# PEDESTRIAN / BICYCLE SAFETY REVIEW

US 1 / Broadway Boulevard to Fay Boulevard

## **Pedestrian/Bicycle Safety Review Report for US 1 (North) from Broadway Boulevard to Fay Boulevard**

## **Project Title: US 1 (North) Pedestrian/Bicycle Safety Review**

Figure 10

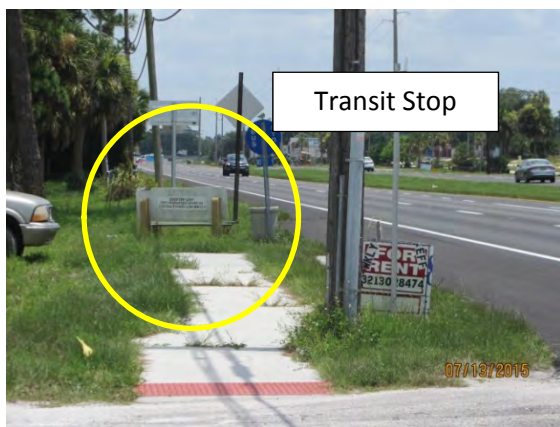
Very little sidewalk connectivity is present along the corridor (see **Figure 8** and **Figure 9**). The only continuous sidewalk located along the corridor is between Broadway Boulevard and Spring Street (which is cracked in spot locations and may need to be replaced) and in front of the CVS (southwest corner of Fay Boulevard intersection), both along the west side of the roadway. Spot sidewalks have also been constructed at three transit stops along the corridor (see **Figure 10**). Sidewalks are present on the west side of the roadway south of Broadway Boulevard and north of Fay Boulevard.

Without sidewalks along most of the corridor, pedestrians are forced to walk on uneven ground in a drainage ditch or on the shoulder next to 55/45 mph traffic.

Sidewalks should be considered along the west side of the roadway throughout the study corridor length. Constructing the sidewalk on the west side would connect the gaps between the sidewalk south of Spring Street and the sidewalk north of Fay Boulevard. Based on observed pedestrian activity during the field review, the sidewalk could be constructed in phases:

- Phase 1 – Spring Street to southernmost Cocoa Flea Market entrance (across from Mahi Mahi Lane)
  - Also consider reconstructing sidewalk from Broadway Boulevard to Spring Street if in poor condition
- Phase 2 – Cottrell Avenue/BP Gas Station to Port St. John Plaza
  - Also consider constructing sidewalk on the east side of the roadway for this segment
- Phase 3 – Port St. John Plaza to CVS driveway just south of Fay Boulevard
- Phase 4 – Southernmost Cocoa Flea Market entrance to Cottrell Avenue
  - During the field review, pedestrians and bicyclists were observed utilizing the frontage road adjacent to the Cocoa Flea Market parking area (see **Figure 11**), thus the reason for this section to be Phase 4

**Figure 21**

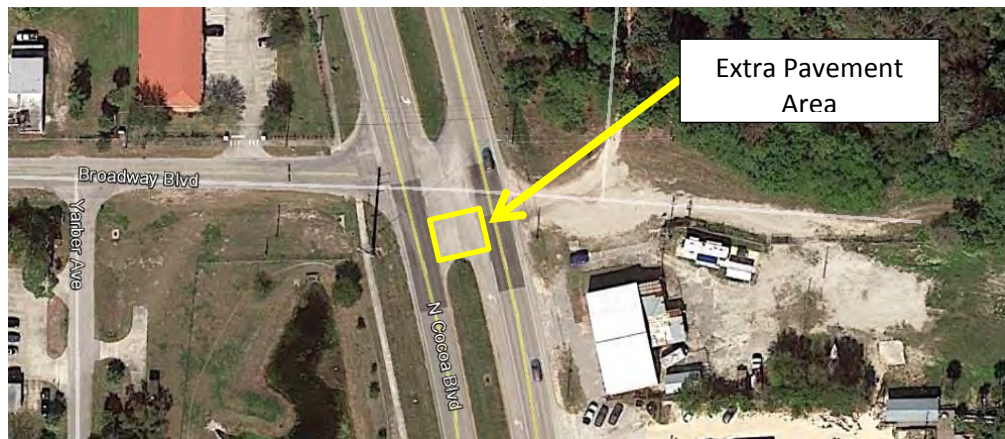
No crosswalk is provided on the Broadway Boulevard approach to US 1 (**Figure 21**). The centerline and stop bar striping for this approach is worn.

Consider painting a crosswalk across the Broadway Boulevard approach. Consider restriping the centerline and stop bar for this approach as well.

**Figure 32**

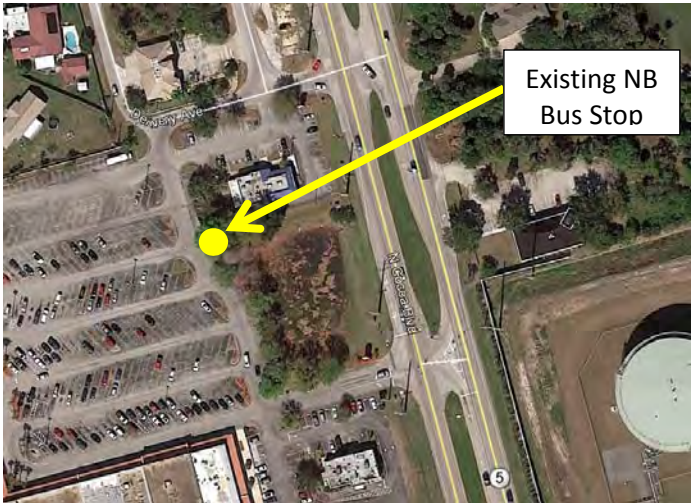
A continuous green northbound through lane is provided at the Port St. John Plaza intersection, as displayed in **Figure 29**. The following signage improvements were proposed for this intersection per the Qualitative Assessment report performed by FDOT Traffic Operations:

- Replace the yellow continuous green through lane sign (**Figure 30**) with a white background continuous lane sign mounted at seven (7) feet.
- Replace the “signal ahead” warning sign just south of the intersection with a custom warning sign indicating approach to continuous green lane.

Currently no pedestrian sidewalks or marked crosswalks are constructed at the intersection (**Figure 31** taken from southwest corner). Due to this, the southbound bus stop is located approximately 400’ north of the intersection and there is no northbound bus stop located along US 1 (**Figure 32**). The buses traveling in the northbound direction left turn onto Delivery Avenue (425’ north of Port St. John Plaza) and stop behind the Burger King in the Winn Dixie parking lot (**Figure 33**). To get back onto northbound US 1, the buses make eastbound left turns at the Port St. John Plaza intersection.

As maintenance-type activity, consider installing the signage improvements as noted in the Qualitative Assessment (see **Appendix C** for Conceptual Improvement Diagram). The continuous green lane sign should also make note of the southbound bicycle lane crossing the intersection.

In the longer term, consider removing this lane in order to accommodate pedestrian movements east/west across the intersection. As discussed in **Issue #2: Sidewalk**, sidewalks should be considered along both sides of US 1 between Cottrell Avenue and Port St. John Plaza (Phase 2) and on the west side of US 1 between Port St. John Plaza and the CVS driveway just south of Fay Boulevard (Phase 3). When sidewalks are constructed, marked crosswalks with pedestrian activated push buttons and signal heads should be considered across the west and south legs of the Port St. John Plaza intersection. Once the sidewalks and crosswalks are constructed, the northbound bus stop located inside the Winn Dixie parking lot could be moved onto US 1 near the intersection. The southbound bus stop could also be moved closer to the intersection.
